In reference to the last two lines of the abstract, we confirm that: no hydraulic or electronic devices are no longer used as hydraulic control mean, because the change from the mechanical way of transmitting the torque from the engine to the driving wheels to the hydraulic way is determined by the capacity of the hydraulic torque converter itself in surpassing the automobile torque demand, after it has been moved first by means of a mechanical device in which the transmission ratio is higher. (The transmission ratio of a hydraulic torque converter of 3 elements (pump, turbine and reactor) is commonly 2,1 to 1, and the mechanical transmission ratio of the mechanical torque converter used in the present transmission is commonly 3 to 1.

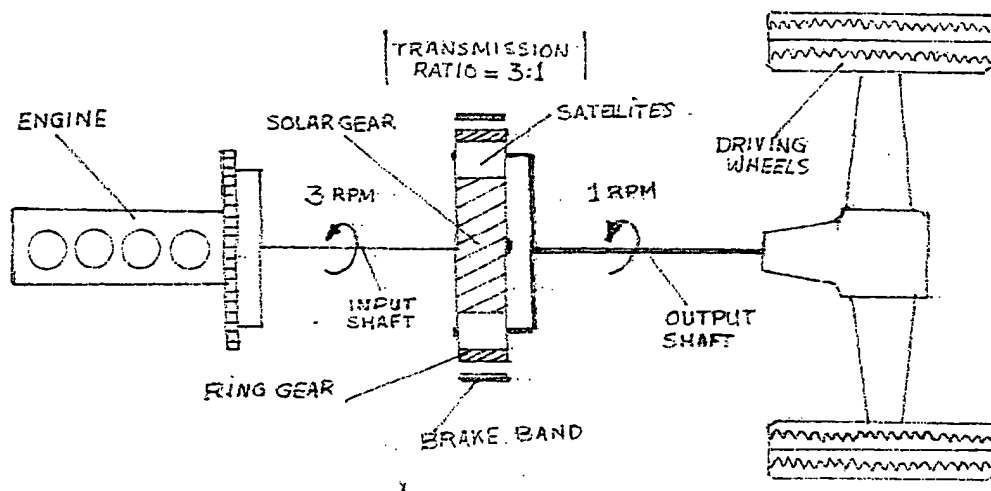
The last two lines of the abstract are correct because no control takes place by means of any hydraulic or electronic devices for changing the torque ratio. The real "brain"(let us use the word brain) is the mechanical connection between the rings gear 5 FIG 1 with the free wheel 11.

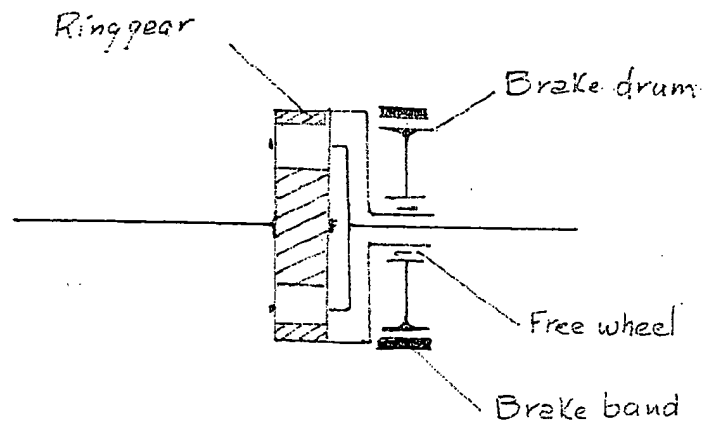
If a brake band is directly applied to the ring gear, the intake shaft will rotate 3 times higher than the output shaft and no change in the transmission ratio is produced if the

ring gear is stopped in both senses (right and left).

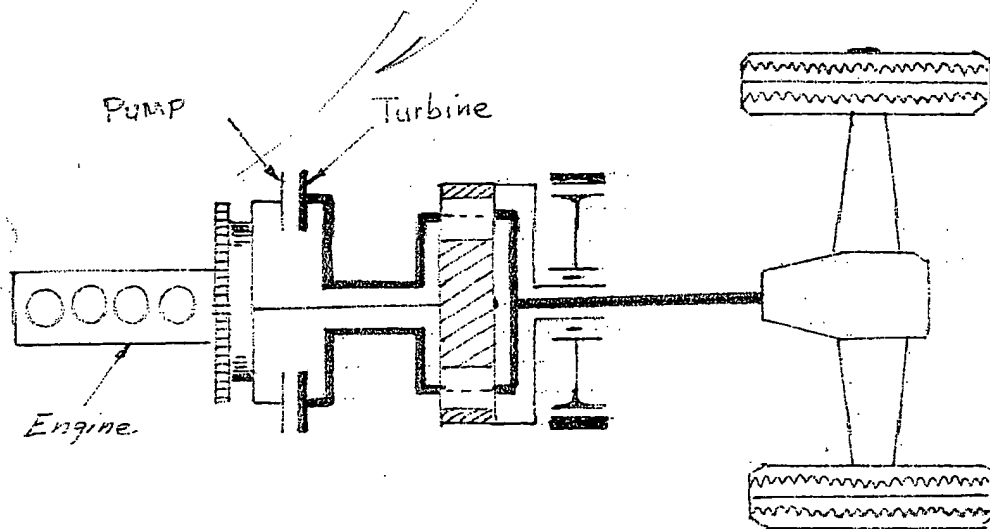
If a brake band is NOT applied directly to the ring gear but to a free wheel located between said ring gear and to a brake drum then, such a ring gear rotation is free in one sense and is stopped at the opposite direction.
